1) Modify Section 142.1.3 as shown below:

142.1.3 Burst Transmission

MsgBurstSync

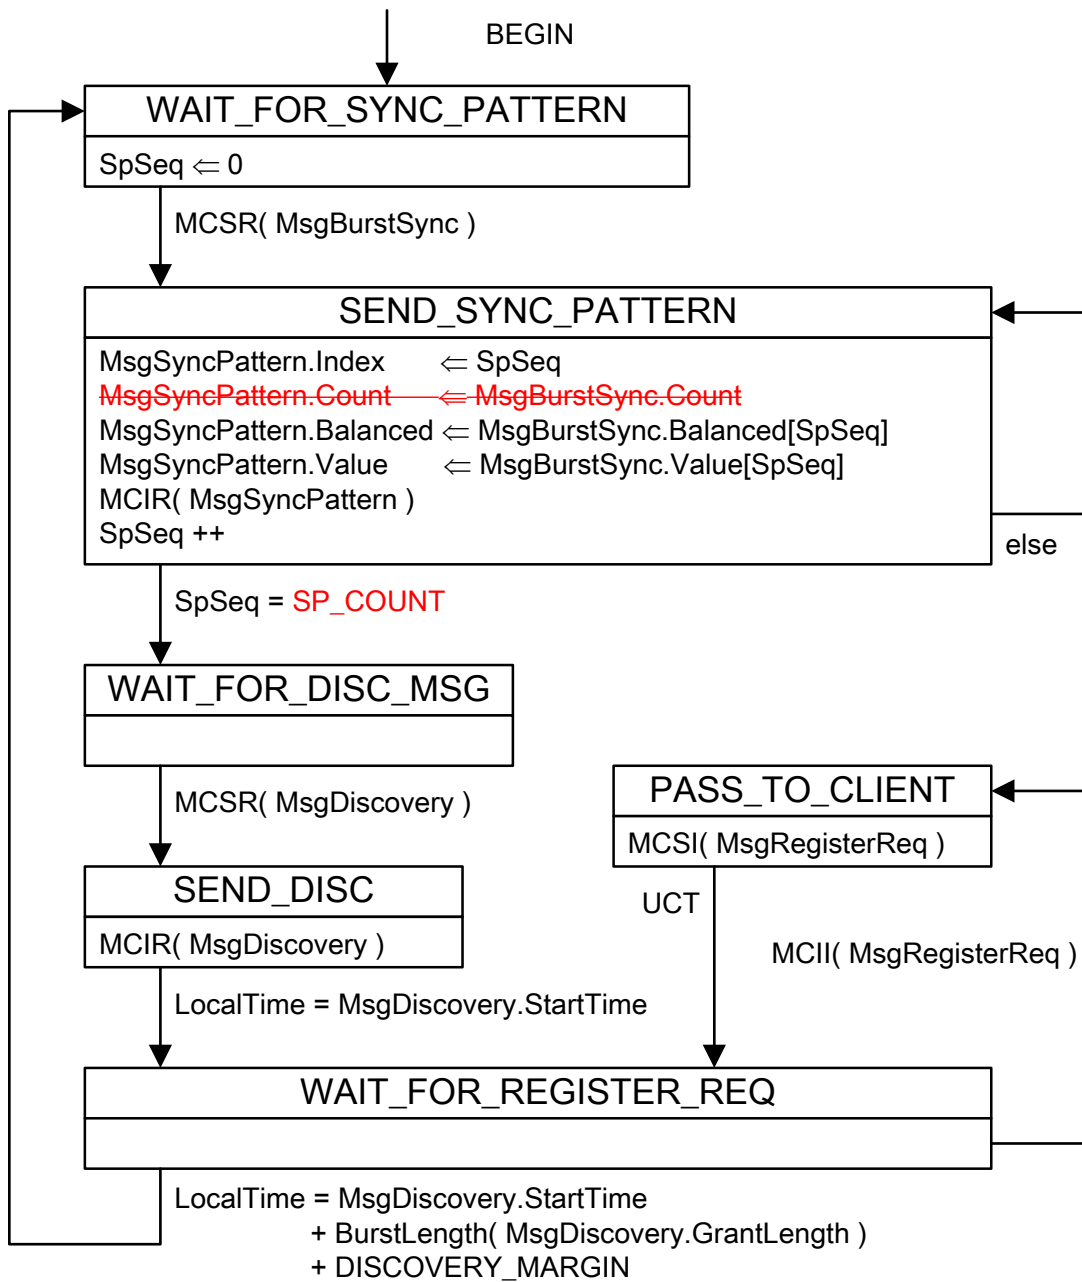
13) Modify definition of MsgBurstSync as follows:

A set of parameters (operand_list) carried in multiple SYNC_PATTERN MPCPDUs. Within the OLT Discovery Initiation Process (see 144.3.7.6), the *MsgBurstSync* set is received from the MPMC Client and is transmitted in ~~2 or 3~~ SYNC_PATTERN MPCPDUs, ~~as determined by the *MsgBurstSync.Count* parameter.~~ Within the ONU Registration Process (see 144.3.7.8), the parameters received in multiple SYNC_PATTERN MPCPDUs are combined and passed to the MPMC Client as a single *MsgBurstSync* set. The *MsgBurstSync* set includes the following parameters:

~~*Count*: The number of synchronization patterns that the ONU is instructed to generate during the discovery attempt. The allowed values are 2 or 3.~~

Balanced[~~*Count*~~*SP_COUNT*]: An array of *SP_COUNT* Boolean values, where the n^{th} element of the array indicates whether the n^{th} synchronization pattern is balanced or not.

Value[~~*Count*~~*SP_COUNT*]: An array of *SP_COUNT* 257-bit values, where the n^{th} element of the array represents the n^{th} synchronization pattern.
